# E-3 AWACS CORROSION PREVENTION ADVISORY BOARD (CPAB)

12 JULY 1990  
TINKER AFB, OK

**E-3 CORROSION PREVENTION ADVISORY BOARD MINUTES  
12 JULY 1990**

FIGURE 7. LIGHT INSTL, EXTERIOR EMERGENCY EXIT  
POWER SUPPLY INSTL, EXTERIOR EMERGENCY EXIT (SHEET 1)

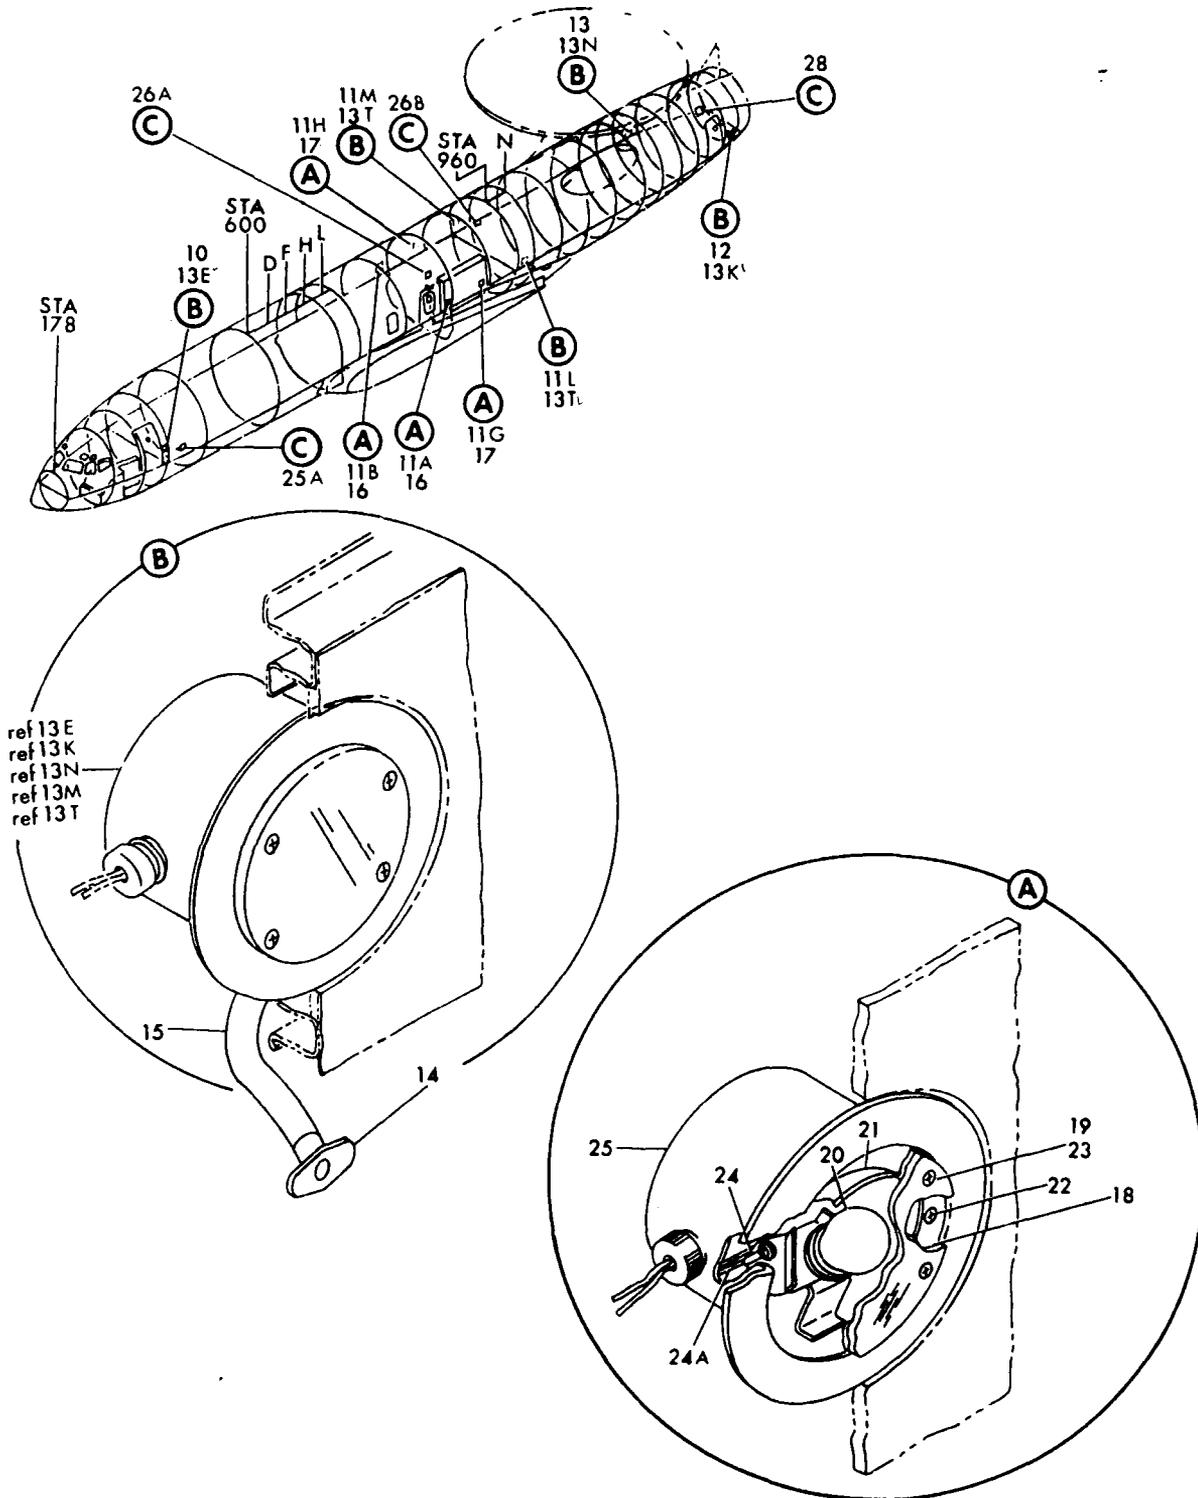
E-3	CORROSION PREVENTION ADVISORY BOARD		ACTION ITEM #: 88-12
O R I G I N A L T O R	<b>SUBJECT:</b> Emergency Exit Lghts	<b>BACKGROUND DATA:</b>  <b>PART NUMBER:</b>  <b>NSN:</b> <b>DRAWING(S):</b> 204-56168, 30-0431/-0432	
	<b>NAME:</b> HFW Franz-Josef Deckers <b>ORGANIZATION:</b> NAEWF E-3A Comp <b>TELEPHONE:</b> 01-49-2451-63-2451 <b>DATE SUBMITTED:</b> May 1988	<b>TO(S):</b> 1E-3A-4-33-1 <b>FIGURE:</b> 33-02-07 <b>INDEX:</b> <b>WORK UNIT CODE:</b> 44A00	
	<b>PROBLEM:</b> Emergency exit lights located by the emergency exits above the wings collect moisture and subsequently corrode. A drain hole exists, but tends to clog up and prevent drainage.		
	<b>RECOMMENDED ACTION:</b> Investigate corrosion/drainage in the emergency exit lights and implement a solution.  <p style="text-align: center;">(USE CONTINUATION SHEET IF NECESSARY)</p>		
C P A B A C T I O N	<b>STATUS:</b> 26 Aug 1988: TCTO is being issued to inspect/remove corrosion in light housing assemblies per existing T.O. procedures and notify OC-ALC/MMKRA of any damage beyond T.O. limits. The TCTO also includes instructions to fill all the space in the housing below the drain with MIL-S-81733, smoothing out the sealant to slope toward the drain. MIL-C-85054 will then be applied to the inside of the light housing prior to light reinstallation, and apply MIL-L-87177 to the socket and base of the light bulb. T.O. 1E-3A-6 inspections will be changed to require disassembly to inspect for standing water and apply CPC.  12 March 1990: Action Item previously closed August 1988 when MMKRTA directed by MMKRA to develop TCTO. No TCTO has been issued. Action Item reopened to track TCTO development, and will remain open until TCTO is published.  <p style="text-align: right;">(continued)</p>

TCTO has already been written by MMKRTA but currently on hold for parts. Kitproof is also on hold. Reflector assy, P/N 31-1560-1 is unavailable at this time.

SEE NOTE ON PARTS LIST PAGES  
 FIGURE 14A. CONTROL INSTL, RUDDER (SHEET 1)

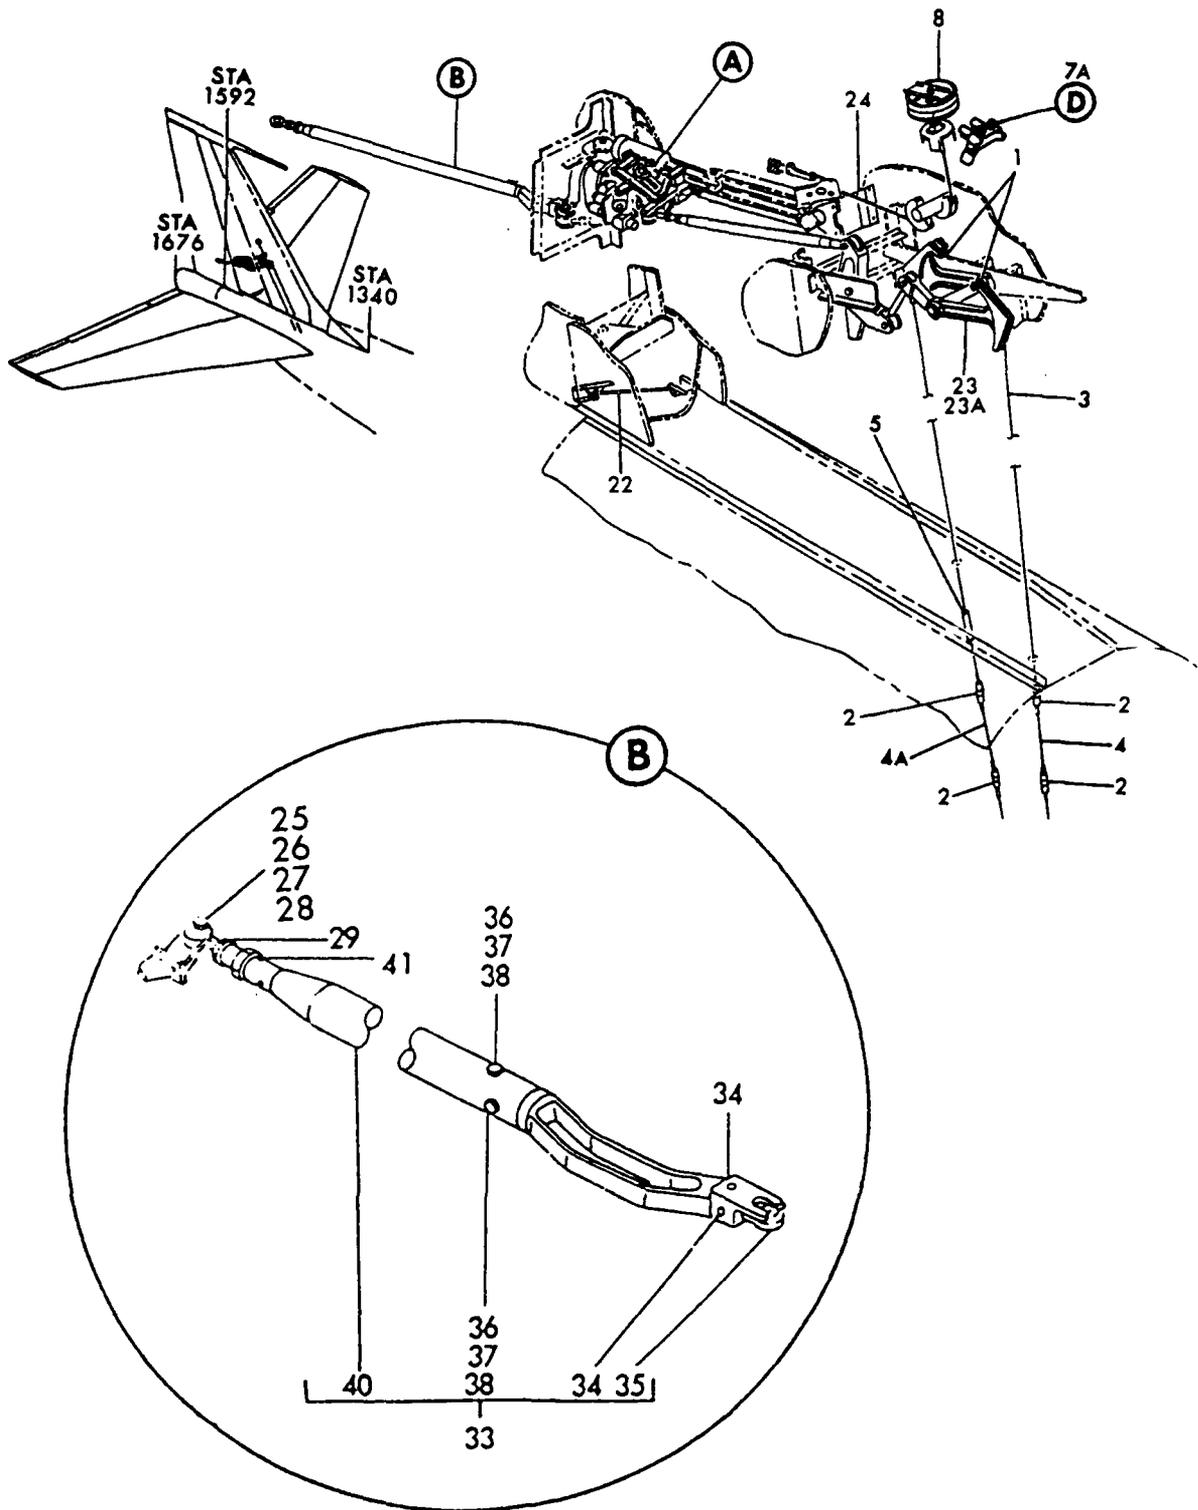
E-3	CORROSION PREVENTION ADVISORY BOARD	ACTION ITEM #: 88-13
O R I G I N A L T O R	<b>SUBJECT:</b> Rudder Control Rod	<b>BACKGROUND DATA:</b> <b>PART NUMBER:</b> 69-14346-2, 69-14345-3 <b>NSN:</b> <b>DRAWING(S):</b>
	<b>NAME:</b> Hfw Franz-Josef Deckers <b>ORGANIZATION:</b> NAEWF E-3 Comp. <b>TELEPHONE:</b> 01-49-2451-63-6215 <b>DATE SUBMITTED:</b> May 1988	<b>TO(S):</b> 1E-3A-4-27-1 <b>FIGURE:</b> 27-09-014A <b>INDEX:</b> 33 <b>WORK UNIT CODE:</b> 14ACA
	<b>PROBLEM:</b> After removing the rod end bearings, NATO workers drained as much as one liter of water out of rudder control rod.	
<b>RECOMMENDED ACTION:</b> Identify proper drain hole configuration for the rudder control rod.  (USE CONTINUATION SHEET IF NECESSARY)		
C P A B A C T I O N	<b>STATUS:</b> 9 SEPT 1988: The rudder control rod is made from 2024 T3 aluminum and was designed to be a closed system. Drain hole configuration is attached  MMKRA will write an Engineering Change Order (ECO) against the drawing and issue a TCTO to ensure drain holes and interior finishes are added to the rudder control rods.  15 NOV 1988: WR-ALC/MMEP cautioned against drilling such a small drain hole. Boeing will provide justification for the .15 +/- .01 inch hole recommended. Stress considerations may require limiting the size of the drain hole. WR-ALC recommended the minimum hole size as .25 inches.  (continued)

An engineering change order (ECO) is being made to the Air Force drawing. After the drawing is changed, a TCTO will be issued to clean and finish the interior of the rudder control rods, and drill the drain hole.

TCTO has been completed and will be published soon. During kit proof, hole was too large and drilled completely through part. TCTO revised to reduce hole diameter to 3/16" and only drill lower side of rod. It was also discovered that attach hardware was loose, corroded, or missing. MMKRA will request all users initiate a one time inspection at O/I for corroded, missing, or loose hardware, and replace if necessary.

Figure 10-21. HF Transmit Components Installation, Wing Tip

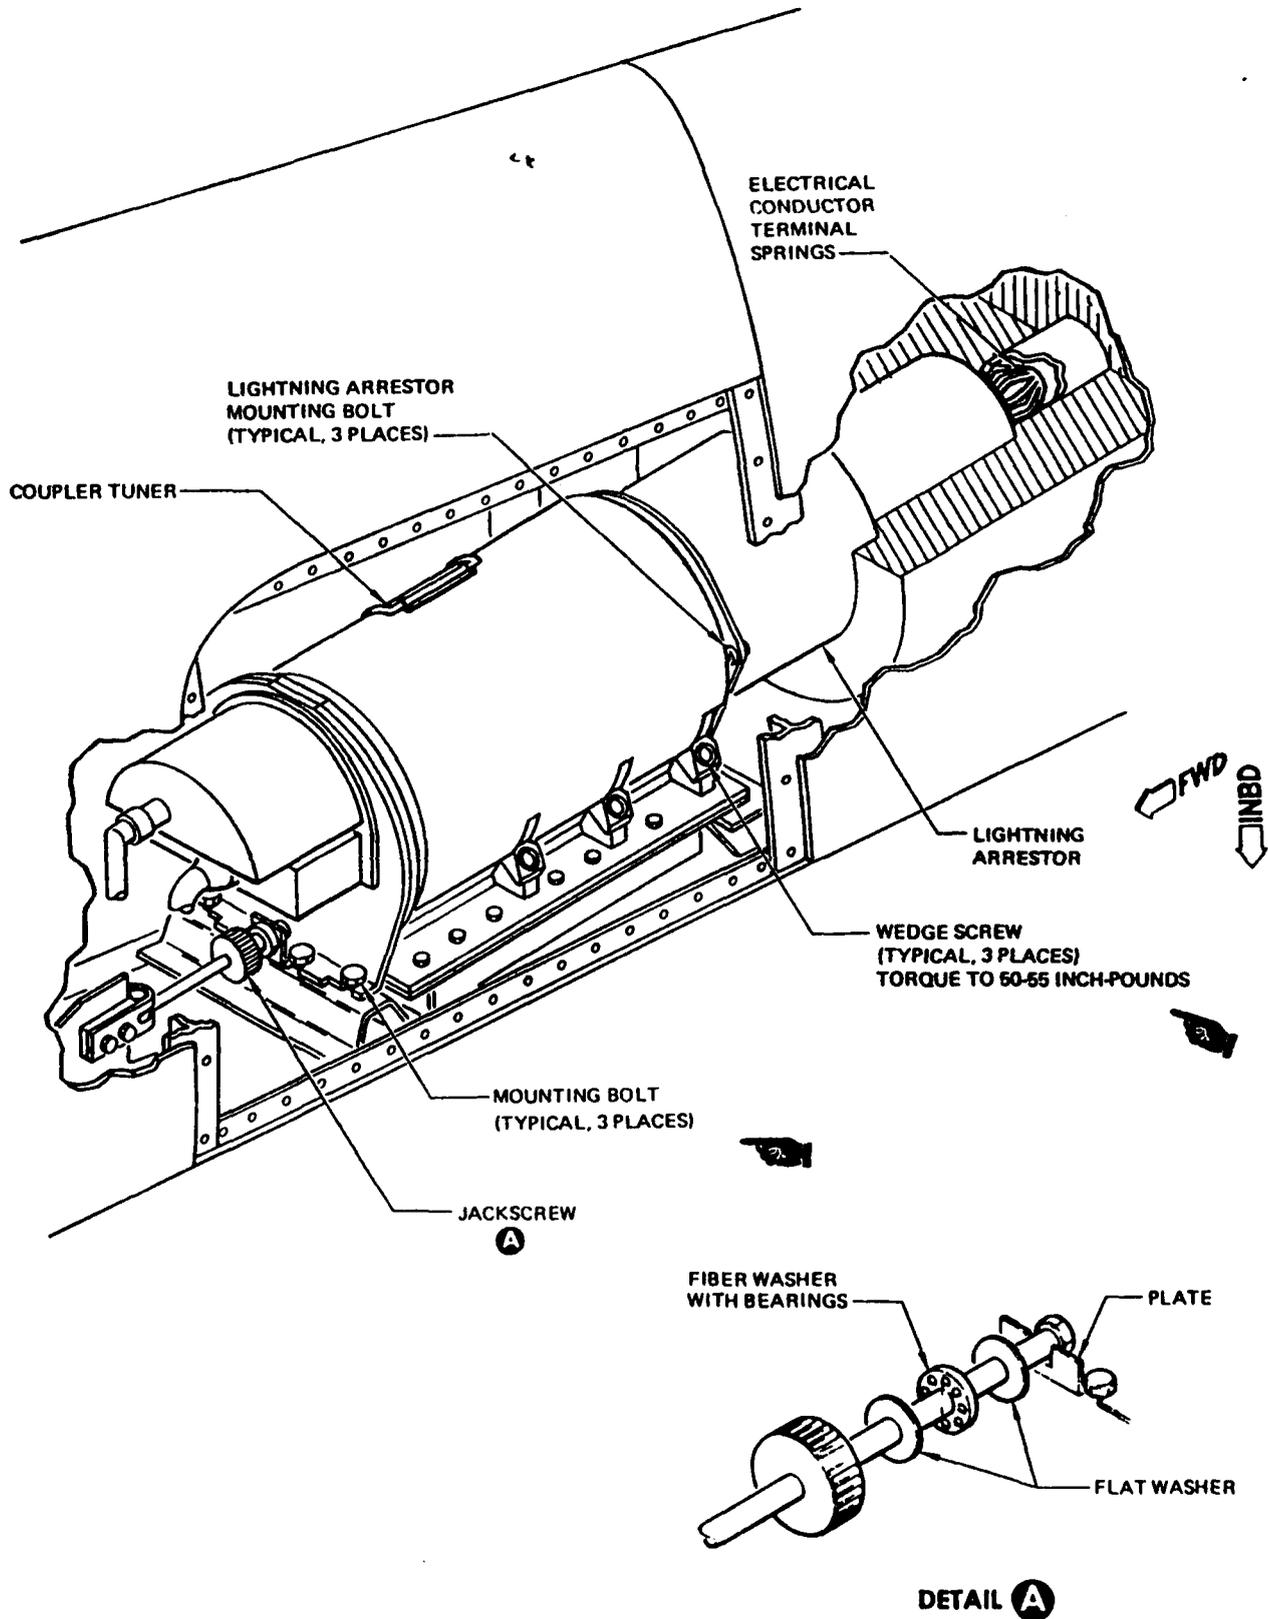
E-3	CORROSION PREVENTION ADVISORY BOARD	ACTION ITEM #: 88-16
O R I G I N A L T O R	<b>SUBJECT:</b> E-3 Wingtip and HF Antenna Corrosion	<b>BACKGROUND DATA:</b>  <b>PART NUMBER:</b>  <b>NSN:</b> <b>DRAWING(S):</b>  <b>TO(S):</b> <b>FIGURE:</b> <b>INDEX:</b> <b>WORK UNIT CODE:</b>
	<b>NAME:</b> Hfw Franz-Josef Deckers <b>ORGANIZATION:</b> NAEWF E-3 Comp. <b>TELEPHONE:</b> 01-49-2451-63-6215 <b>DATE SUBMITTED:</b> May 1988	<b>PROBLEM:</b> NATO discovered severe corrosion on HF antennas located in the E-3 wingtips as well as corrosion on wingtip structure. Water remains trapped in the wingtips after washing. Adding more drain holes in this area may help.
	<b>RECOMMENDED ACTION:</b> Identify manufacturing processes and materials and configuration of HF antennas located in E-3 wingtips. Identify possible solutions to inhibit corrosion.  <p style="text-align: center;">(USE CONTINUATION SHEET IF NECESSARY)</p>

OC-ALC/MMKRA will take responsibility for installing another drain hole to allow condensation to drain and allow more air to circulate in to the area, and to change tech data to require a more frequent inspection of the wingtip antenna. Boeing will investigate the possibility of treating the foam with a material to keep it from absorbing water.

OC-ALC/MMKRA is generating TCTO to drill drain hole and add leveling compound. TCTO will be finished by next CPAB.

Reported foam cracking was investigated by MMKRA and found not to be a significant problem. EST would require an exhibit, which is unavailable. No EST will be pursued, and any future problems will be corrected on a case-by-case basis.

# E-3 LANDING GEAR DRAG STRUT / SHOCK STRUT BOLT

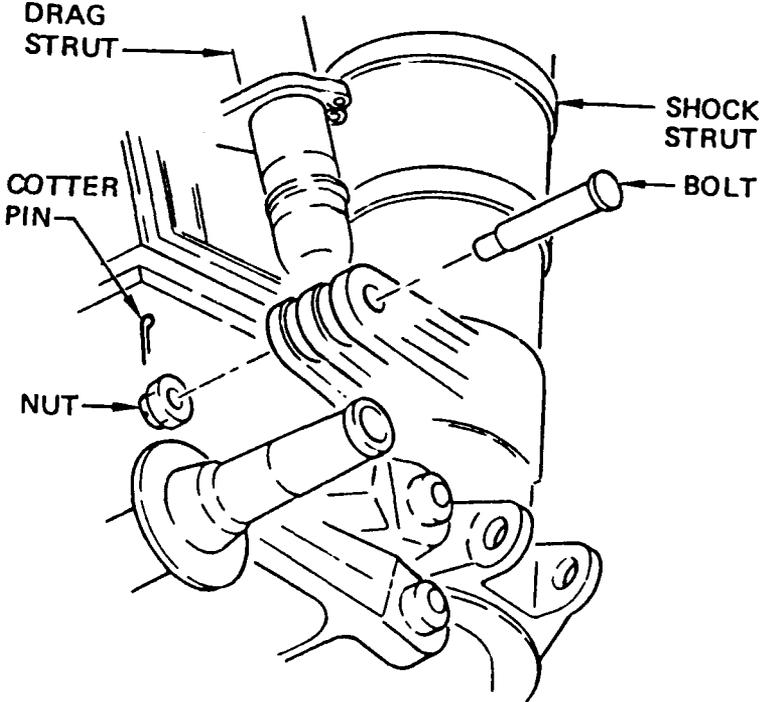
MIL-S-81733 works better than MIL-S-8802, however bolts are still difficult to remove. DINOL AV5 was applied in Dec 88 and Mar 89, and bolts were more easily removed than before, yet bolts were still not easily removed. It was suggested that a product used by European commercial airlines called MASTINOX (See AI 89-04) be tried.

NAEWF E-3A Component has no results because it only has been approximately one year since the application of MASTINOX to landing gear bolts.

Figure 3-6 Stabilizer and Elevator Access Panels (Sheet 1 of 8)

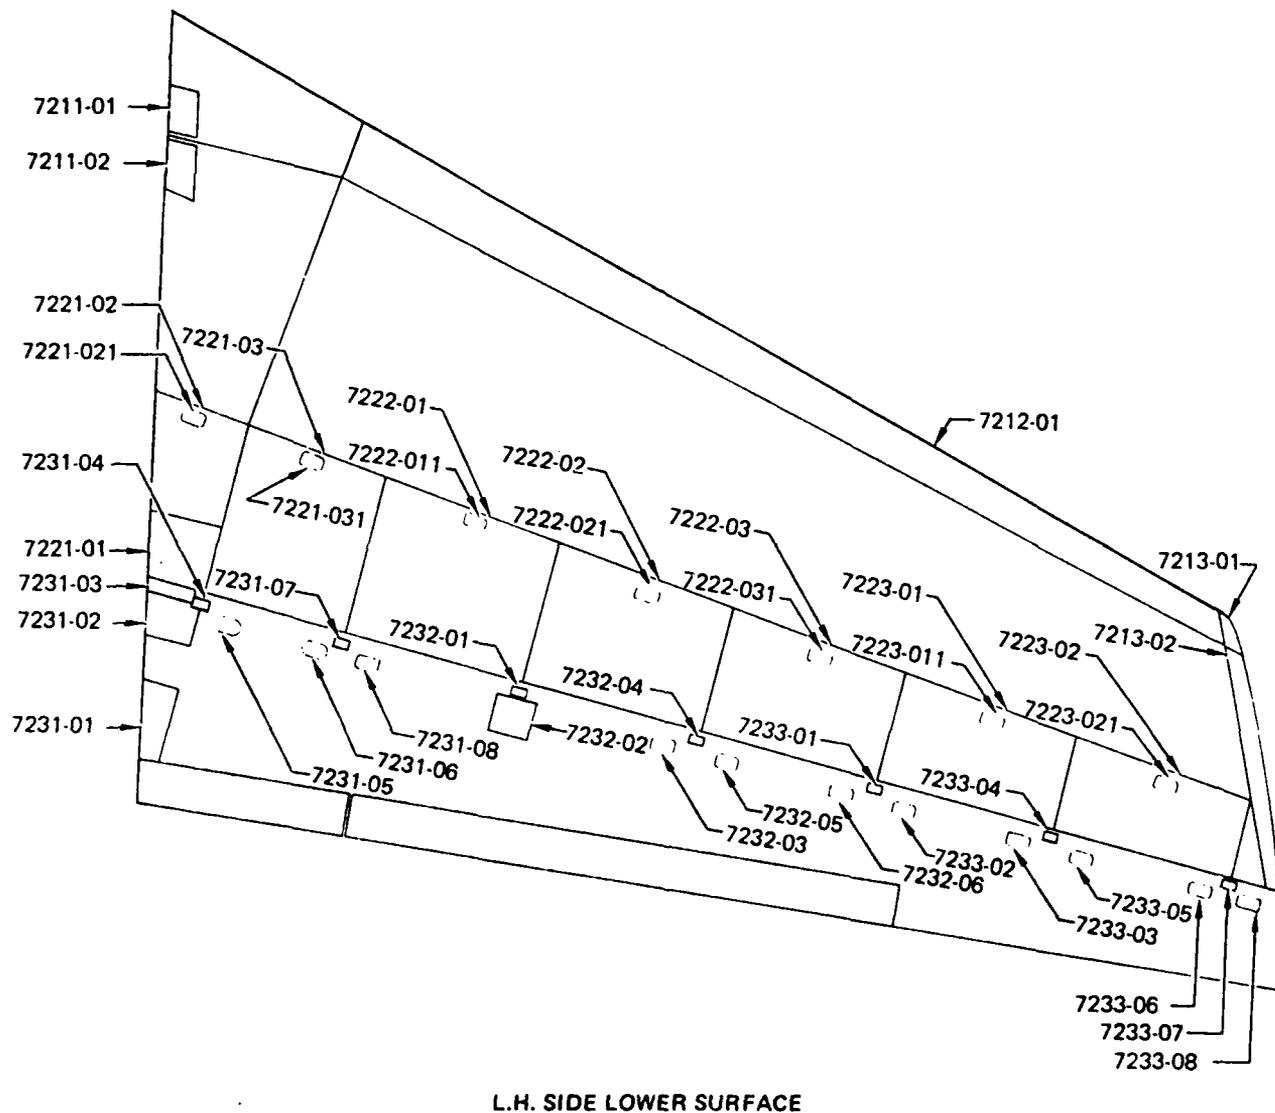
E-3	CORROSION PREVENTION ADVISORY BOARD	ACTION ITEM #: 88-25
O R I G I N A L T O R	<b>SUBJECT:</b> Elevator Thrust Hinge Access Panel	<b>BACKGROUND DATA:</b> <b>PART NUMBER:</b> Panels 7231-03, 8231-03 <b>NSN:</b> <b>DRAWING(S):</b>
	<b>NAME:</b> HFw Franz-Josef Deckers <b>ORGANIZATION:</b> NAEWF E-3A Comp <b>TELEPHONE:</b> 01-49-2451-63-6215 <b>DATE SUBMITTED:</b> May 1988	<b>TO(S):</b> 1E-3A-23 <b>FIGURE:</b> 3-6 <b>INDEX:</b> <b>WORK UNIT CODE:</b> 11FDL, 11FGN
	<b>PROBLEM:</b> Standing water in this panel is a problem.	
<b>RECOMMENDED ACTION:</b> Initiate action to provide drain holes in the elevator thrust hinge access panels.  (USE CONTINUATION SHEET IF NECESSARY)		
C P A B  A C T I O N	<b>STATUS:</b> 2 Sept 1988: A TCTO is being issued to drill a 0.30 inch diameter drain hole on the lower surface access panels (7231-03 and 8231-03) 3 inches inboard of the existing inboard drain hole and on the same centerline of both existing drain holes. MIL-S-81733 is then applied to channel water toward the new drain hole. ECO being issued to change configuration on drawings.  12 March 1990: Action Item originally closed Sept 1988 after ECO prepared and MMKRTA tasked to draft TCTO. No action has been taken regarding issue of TCTO. Action Item reopened at March 1990 CPAB due to lack of TCTO. OC-ALC/MMKRA/MMKRTA will ensure TCTO is completed as necessary.  July 1990: TCTO will not be generated due to the forging of the material. MMKRTA will develop ACI procedures to apply CPC, and add a leveling compound. Fasteners prohibit drilling of drain hole.
